Agenda Item # 3

SUB-003804-2026

Royal Lee Wilson Subdivision

ROYAL LEE WILSON SUBDIVISION

DETAIL SITE PLAN

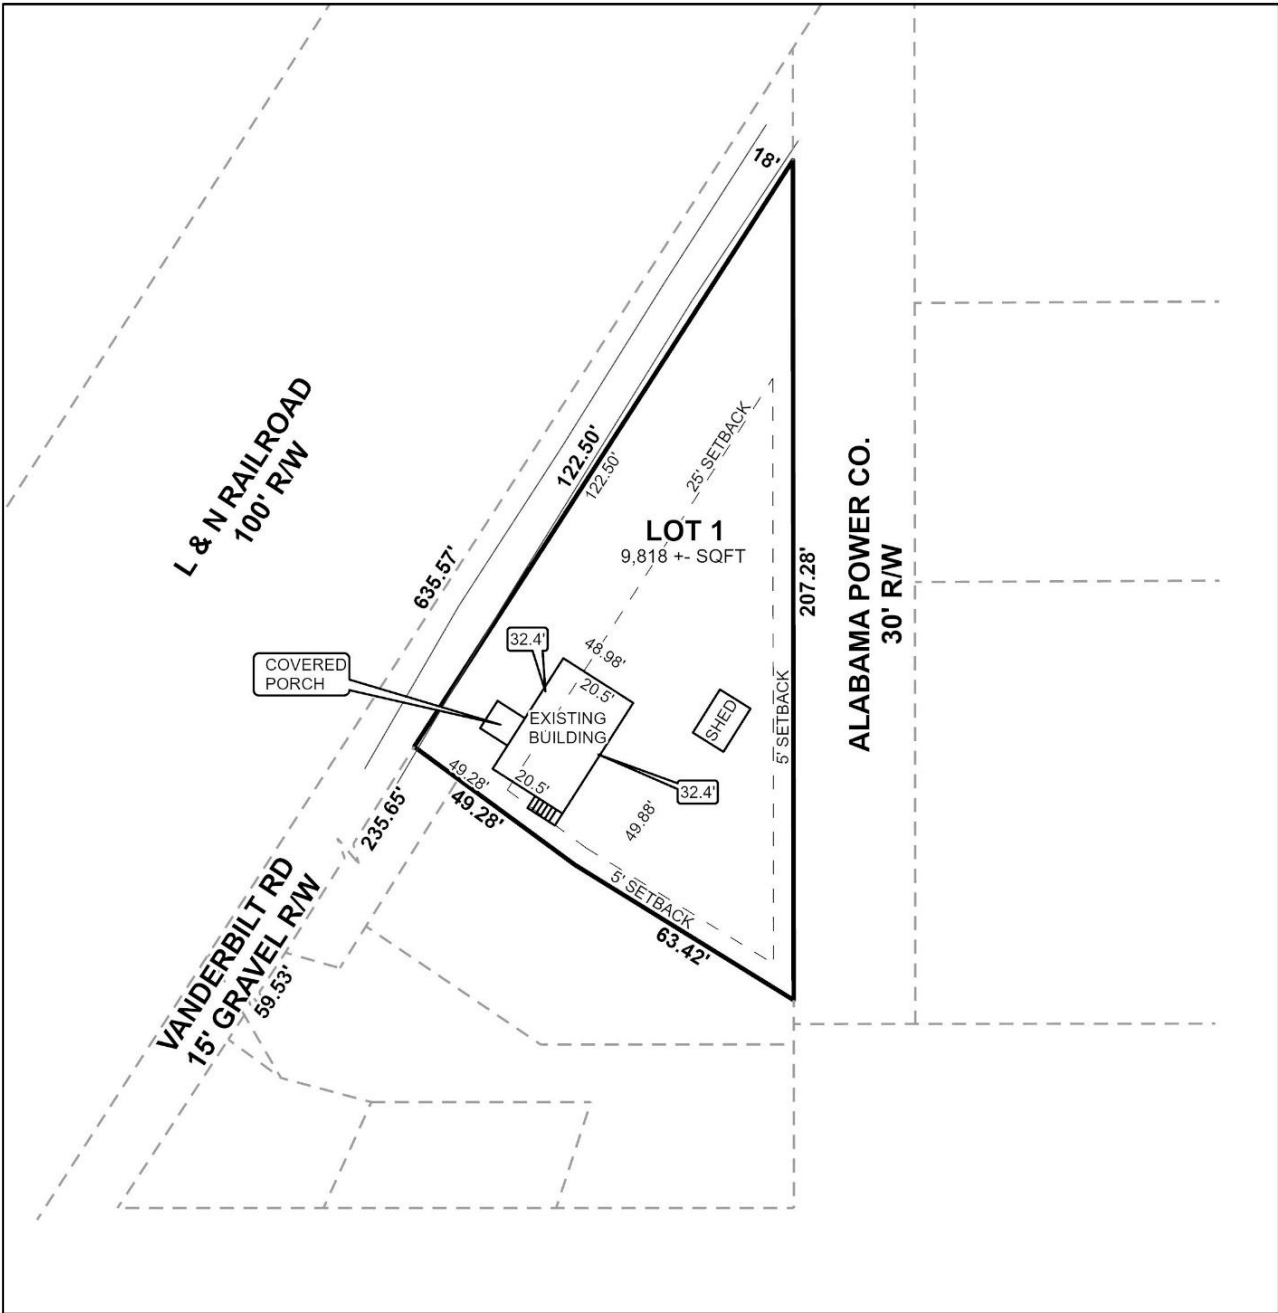
- A. Provide all the required information on the SUBDIVISION PLAT (i.e. signature blocks, signatures, certification statements, written legal description, required notes, legend, scale, bearings and distances) that is required by the current Alabama State Board of Licensure for Professional Engineers and Land Surveyors.

- B. Label "Island Road" on the FINAL PLAT.
- C. Add a North Arrow.
- D. Add a graphic scale.
- E. Provide the recording data for Vanderbilt Road 15' ROW.

- F. Clarify if the access is named Vanderbilt Road or Vanderbilt Drive.
- G. Show and label Hamilton Blvd. ROW.
- H. Revise ENGINEERING COMMENTS #1 to read "As shown on the 1984 aerial photo LOT 1 will receive 1,000 sf of historical credit of existing (1984) impervious area towards stormwater detention requirement per Mobile City Code, Chapter 17, Storm Water Management and Flood Control) and 4,000 SF credit provided to the original SF residential lot as follows: LOT 1 – 5,000 sf. Stormwater detention will be required for any additional impervious area that exceeds the allowable credit for that LOT.

- I. Retain ENGINEERING COMMENTS 2 - 6.
- J. Email a pdf copy of the FINAL SUBDIVISION PLAT and LETTER OF DECISION to the Permitting Engineering Dept. for review at land.disturbance@cityofmobile.gov prior to obtaining any signatures. No signatures are required on the drawing.

The proposed lot does not abut a public street, as required by Section 6.C.4. of the Subdivision Regulations. Instead, access is facilitated by a 15-foot-wide ingress/egress easement to Hamilton Boulevard. Considering the property appears to have existed in its current configuration prior to annexation, and was developed prior to current regulations, a waiver of Section 6.C.4. of the Subdivision Regulations may be appropriate.

There is no minimum size requirement for lots served by public water and sanitary sewer in an I-1 zoning district, but the size of the proposed lot is provided in both square feet and acres on the preliminary plat. If approved, the lot size label should be retained on the Final Plat, or a table should be furnished on the Final Plat providing the same information.

A 25-foot minimum front yard setback is illustrated on the preliminary plat, as required under Section 6.C.8. of the Subdivision Regulations. This should be retained on the Final Plat, if approved. The preliminary plat illustrates 5-foot minimum side and rear yard setbacks, and these should be removed from the Final Plat, if approved, as there are no side or rear yard setback requirements for lots in an I-1 zoning district.

1. Retention of the lot size label in square feet and acres on the Final Plat, or the furnishing of a table on the Final Plat providing the same information;
2. Retention of the 25-foot minimum front yard setback on the Final Plat;
3. Revision of the plat to remove the 5-foot side and rear yard setbacks;
4. Compliance with all Engineering comments noted in this staff report;
5. Placement of a note on the Final Plat stating the Traffic Engineering comments noted in this staff report;
6. Compliance with all Urban Forestry comments noted in this staff report; and
7. Compliance with all Fire Department comments noted in this staff report.
